Access Compliance Report

Intersection ID: 51538	Main Street: GLENBURN_LN	Cross Street: KINGAUSSIE	Location: NW
ADA ID: 9E0A4A491153	Ramp Type: BlendTrans1	Initial Pass/Fail: Fail	Overall Compliance: No
			Severity Score: 21.25

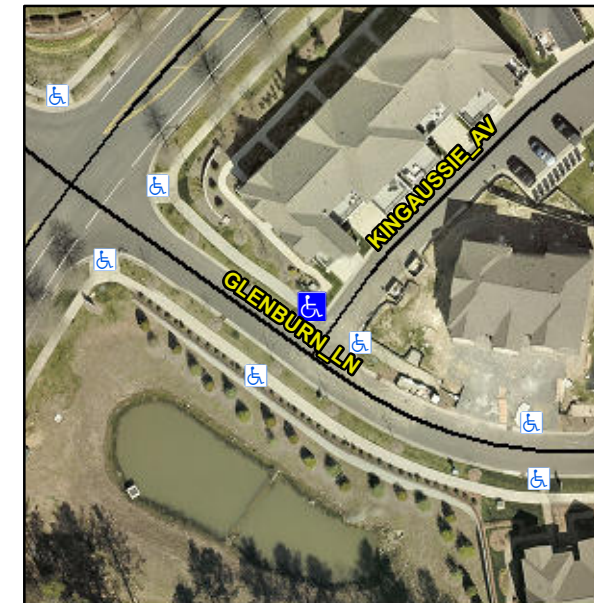
Not Found, R304.5.1, R304.5.3

Compliance	Description	Data	Compliance	Description	Data
N/A	Ramp Length (in)	48.0	Yes	BlendTrans Slope (%)	3.1
No	Ramp Width (in)	47.5	No	BlendTrans XSlope (%)	6.2
N/A	Flare Type LT	N/A	N/A	Flare Type RT	N/A
N/A	Flare Slope LT (%)	N/A	N/A	Flare Slope RT (%)	N/A
N/A	Flare Traversable LT?	N/A	N/A	Flare Traversable RT?	N/A
N/A	Landing Length (in)	N/A	N/A	DWS Provided?	N/A
N/A	Landing Width (in)	N/A	N/A	DWS Contrast?	N/A
N/A	Landing Slope (%)	N/A	N/A	DWS Length (in)	N/A
N/A	Landing X Slope (%)	N/A	N/A	DWS Full Width?	N/A
N/A	Landing Curb? (Y/N)	N/A	N/A	DWS Offset (in)	N/A
N/A	Shared Landing?	N/A			
N/A	Gutter Ponding?	N/A	N/A	Gutter Slope (%)	N/A
N/A	Gutter Lip Ht (in)	N/A	N/A	Gutter X Slope (%)	N/A
N/A	Painted X Walk1?	No	N/A	Painted X Walk2?	No
	X Walk 1 Direction	To SW		X Walk 2 Direction	To SE
	X Walk 1 Width (in)	N/A		X Walk 2 Width (in)	N/A
	X Walk 1 Slope (%)	2.9		X Walk 2 Slope (%)	0.6
	X Walk 1 X Slope (%)	4.0		X Walk 2 X Slope (%)	3.3

Remove & Replace Curb Ramp With Two New Directional Ramps or Equivalent.
